CLEAR CHANNEL CORPORATION

AR-3300 TECHNICAL BULLETIN #1
APR 4, 1986

AR-3300 TECHNICAL BULLETIN #3
APR. 23, 1986

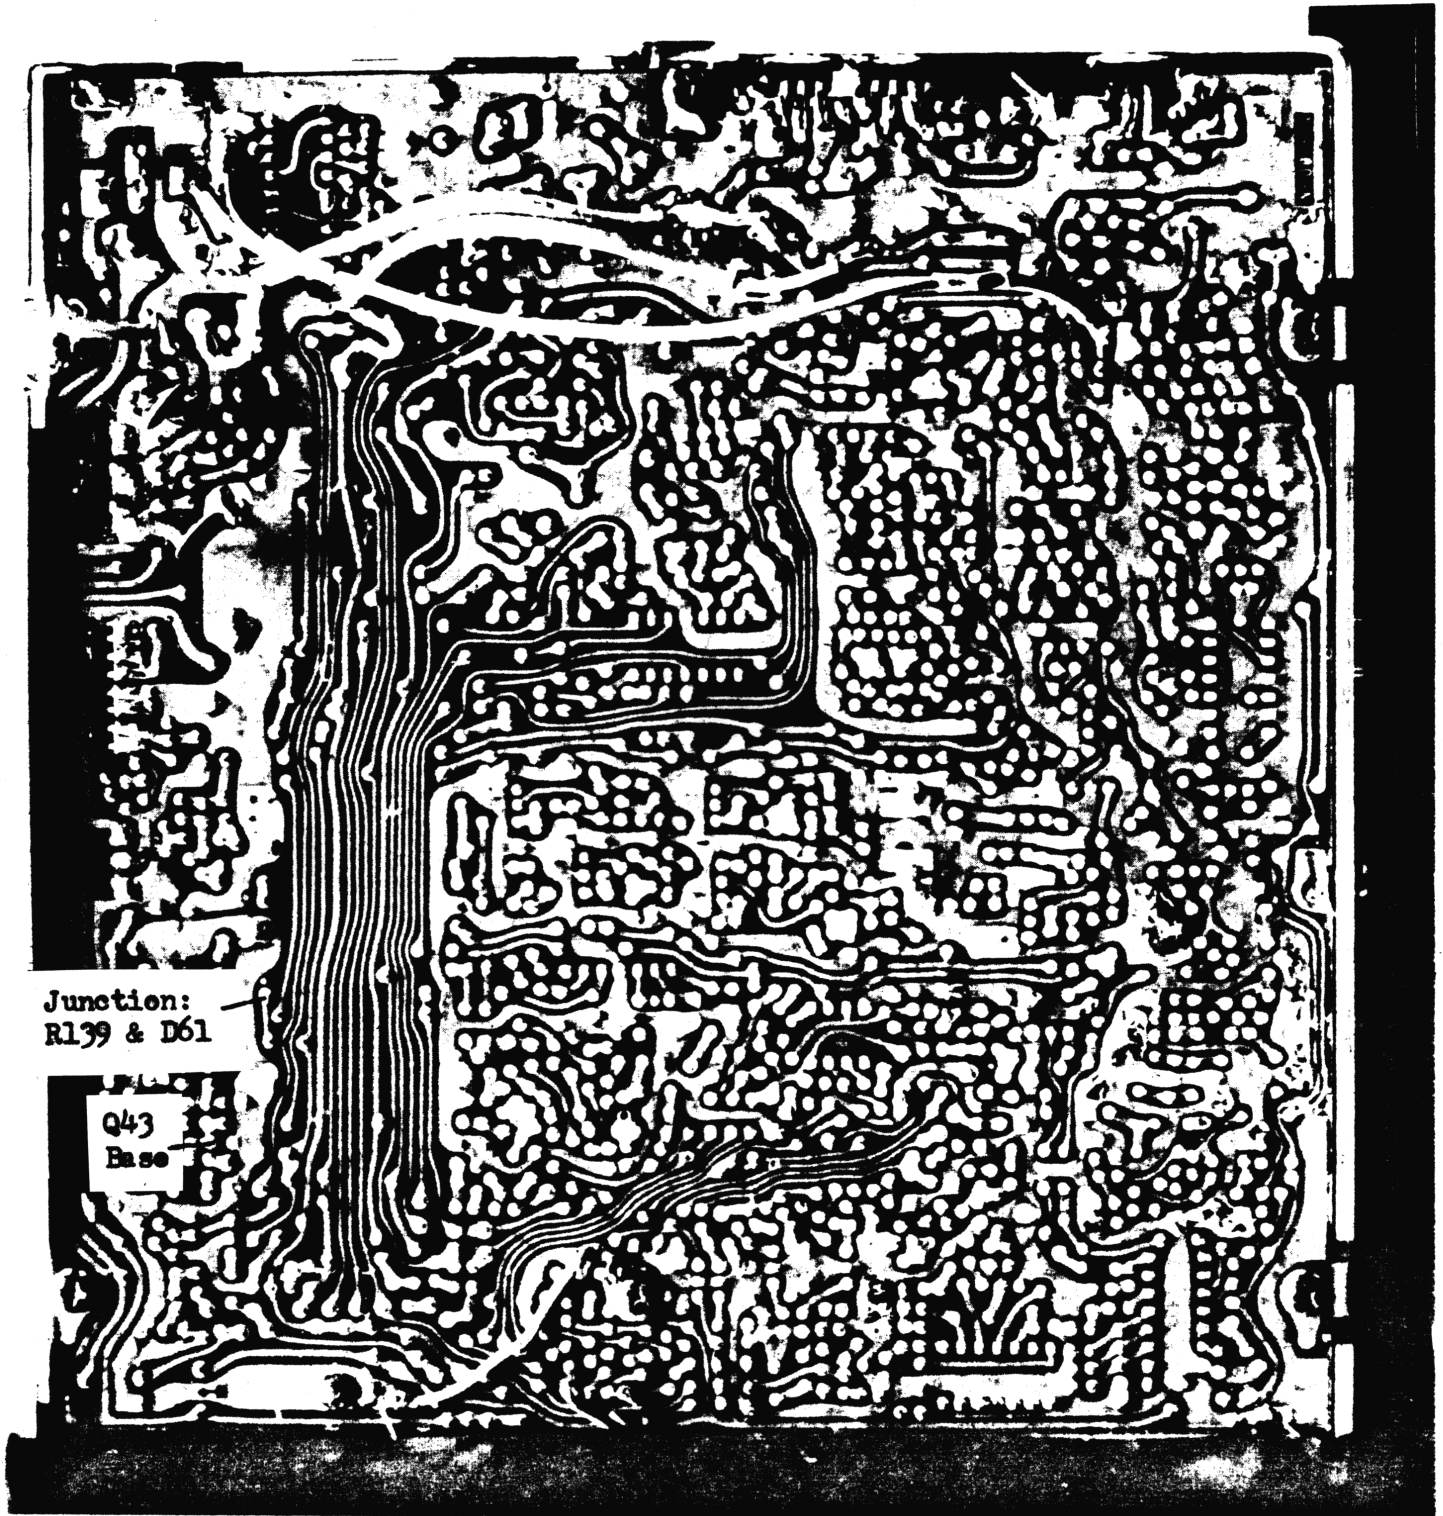
SYMPTOMS: Warble (frequency shift) on SSB. Squeal (audio oscillation) on AM.

CAUSE: Ground loop and by-pass problems on PCB.

REMEDY: Connect open in ground plane on PCB near audio IC8 (see page 2, location A). Connect a .01 capacitor from the spot where ground plane is connected to chassis.

Tighten screws that hold PCB to chassis.

Add by-pass capacitor (.01) at location B (see page 2, location B).

Junction:
R139 & D61

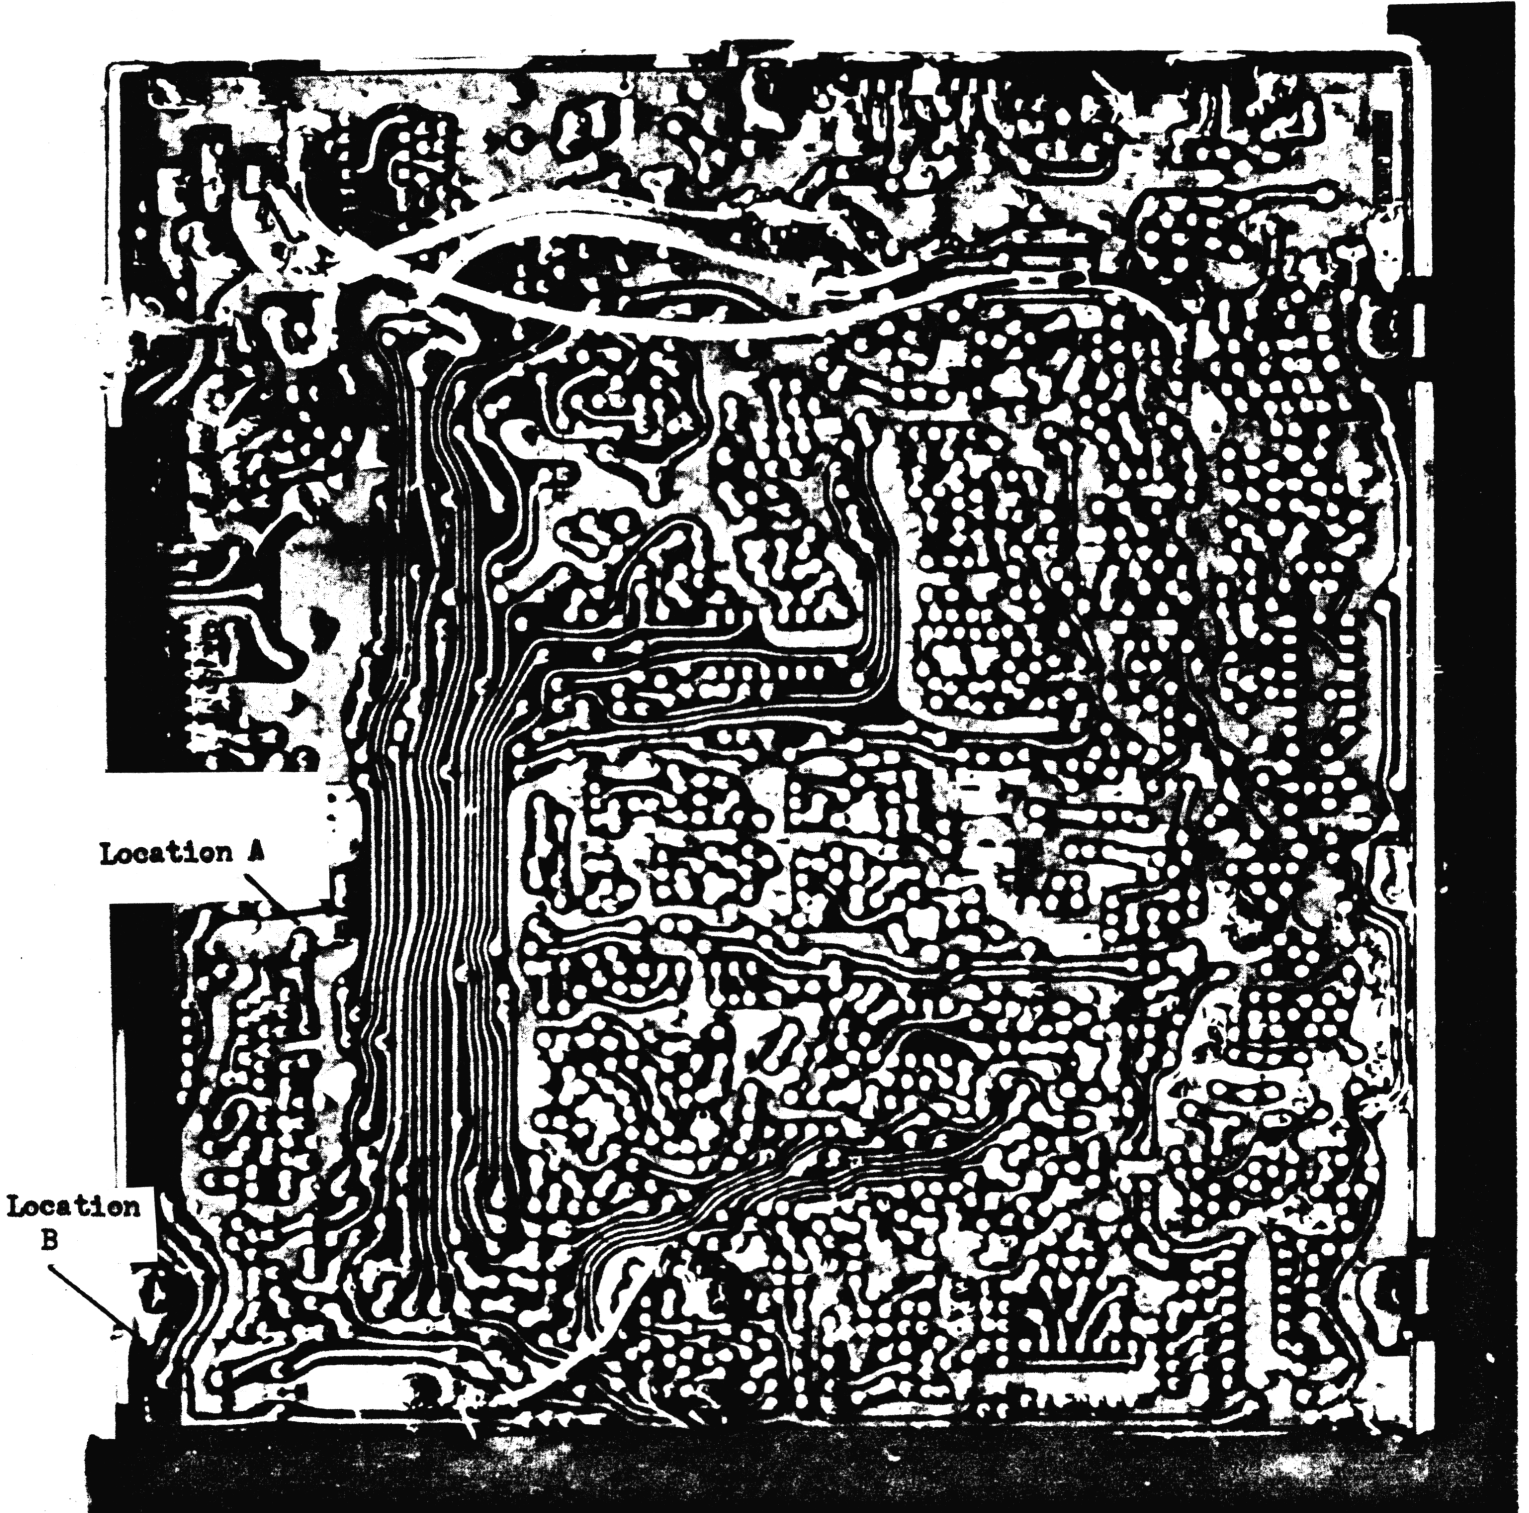
SYMPTOM: First word clipped off.

CAUSE: Modulation amplifier slow turning on (.25 to .5 sec.)

REMEDY: Change R139 to 4.7 Kohm. Move the cathode of D61 to the base of Q43. Add 220 mfd @ 16V + side to anode D61, - side to ground. (Diode and cap should be placed on bottom {solder side} of PCB for best results.

Q43
Base

NOISE BLANKER SWITCH

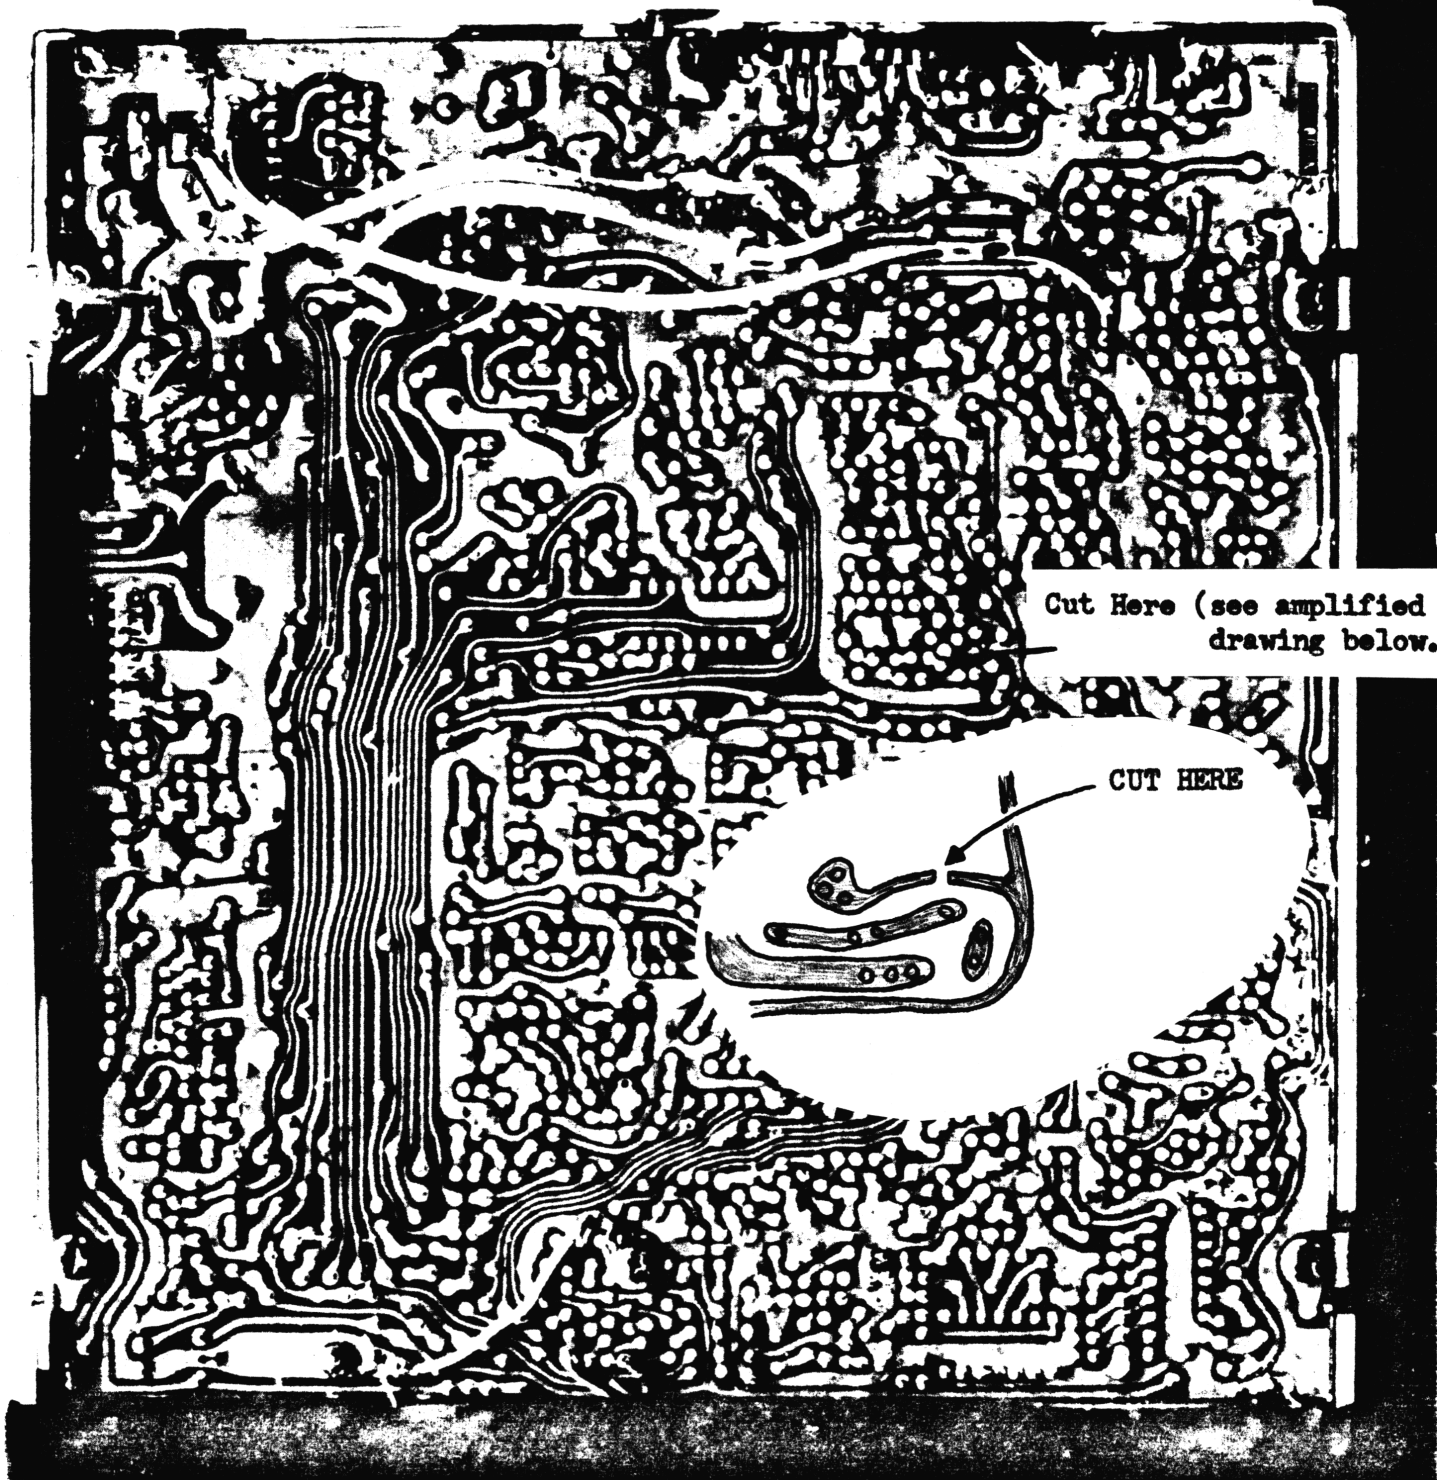
To turn off the noise-blanker cut the trace marked below. A SPST switch can be installed at the cut for a control.

Cut Here (see amplified drawing below..)

CUT HERE
